Report of the Chief Planning Officer

CITY PLANS PANEL

Subject: APPLICATION 13/00288/RM – RESERVED MATTERS APPLICATION FOR 177 HOUSES, ONE BLOCK OF 9 APARTMENTS AND ONE BLOCK OF 6 APARTMENTS INCLUDING ASSOCIATED LANDSCAPING AT OPTARE, MANSTON LANE, CROSS GATES, LEEDS, LS15 8SU.

13/00288/RM

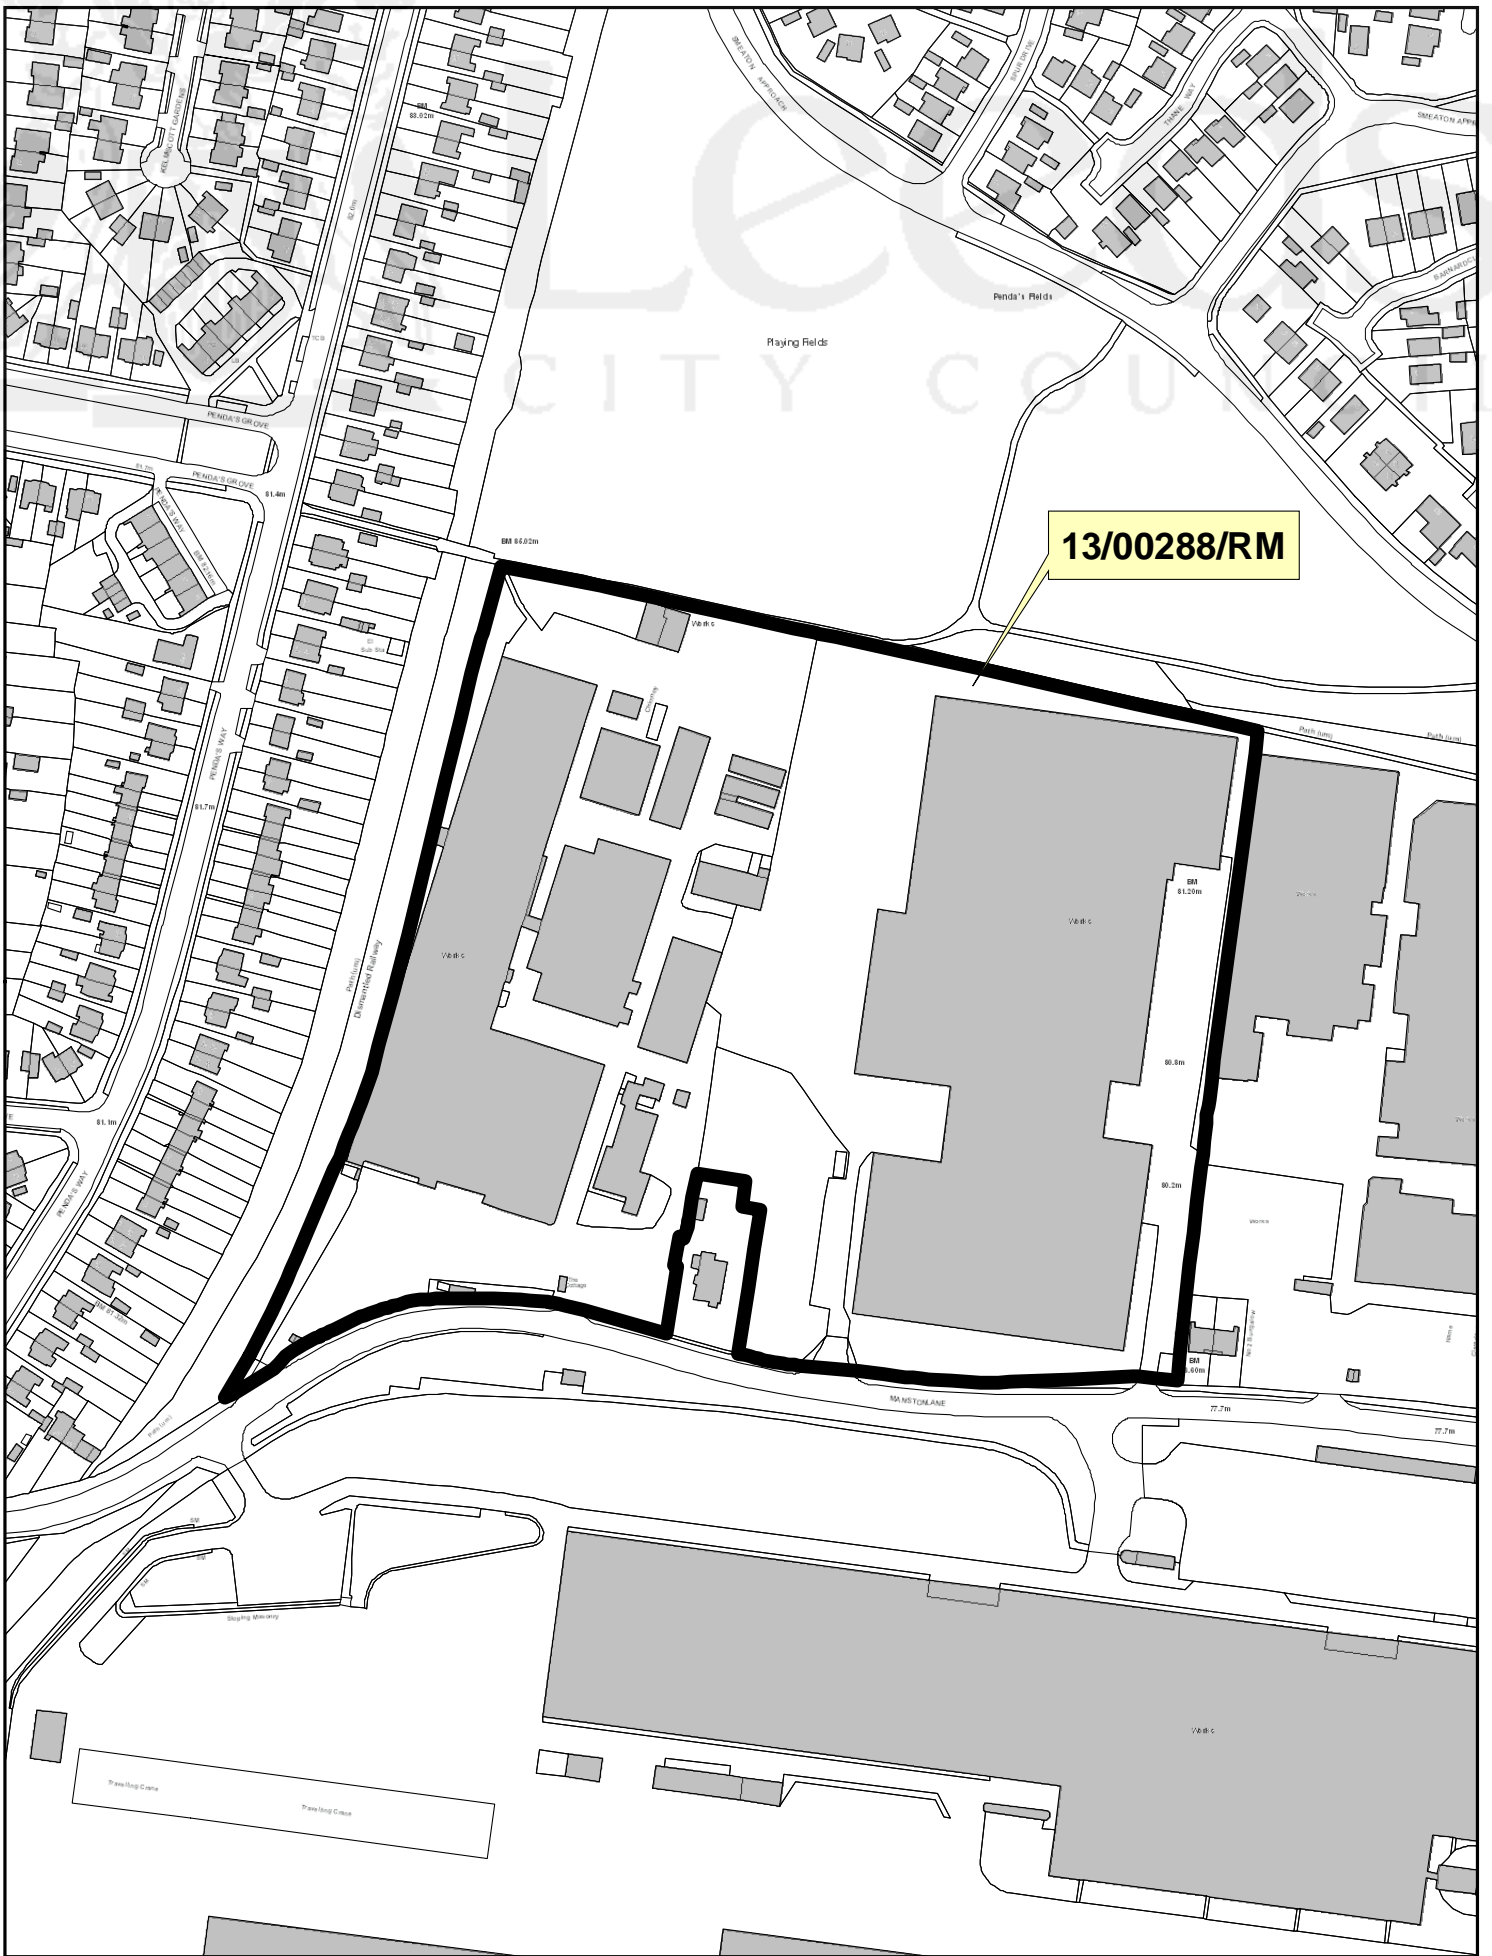
Members commented on the following matters:

- the separation distances and that across the site these were not acceptable
- the public open space and whether this was considered to be in the correct place. Officers were of the view that the central area was the most appropriate location for the POS and that it ensured it was easily accessible from all properties
- that the report referred to ginnels and that these must be removed and there should be no alleyways
- the phasing of the scheme and the number of properties to be delivered in the first phase. Members were informed that the first phase was restricted to 138 units, although the condition could be varied slightly to accommodate the 115 houses the developer wished

- that the proposals represented overdevelopment
- that there was a need to ensure there was a masterplan for this area
- the symmetry of the site and that this was not enhanced by the proposed house types and materials; that much more work was needed to improve the quality of the design of individual units and the layout generally and that it would be helpful for Members to see this site in context with the development on the adjacent site

- the position of driveways and parking which created a much too linear scheme
- the need to ensure that if the density of the scheme was reduced, that the same amount of POS, i.e. 10% of the site, was being provided

- that the proposed house types were of a poor standard from a volume house builder and that further discussions were needed between Officers and the developer to devise a more acceptable scheme
